Product Change Notice

PCN#: EE-PCN26033
September 4, 2026

CLASSIFICATION OF CHANGE:
Certification change

BEFORE	AFTER
Body marking 6.3A

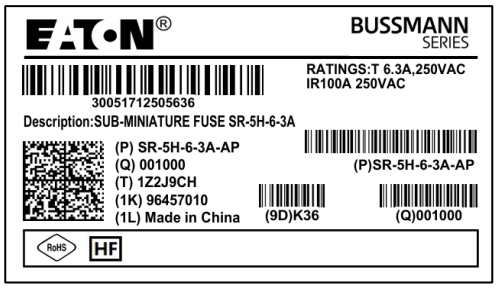
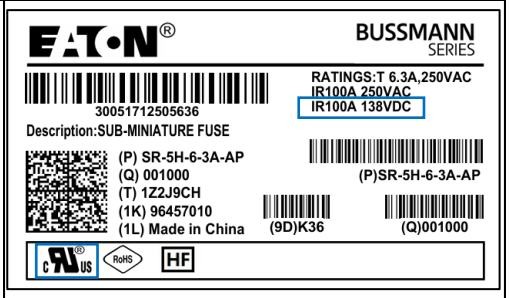
DESCRIPTION OF CHANGE:
The Fuse SR-5H series has added UL certification an interrupting rating (IR) IR100A at 138Vdc.

REASON FOR CHANGE:
The SR-5H Fuse series is now certified for DC voltage. The interrupting rating of 100A @ 138Vdc is now under certification. Product marking and packaging labels have been updated accordingly, as shown below.
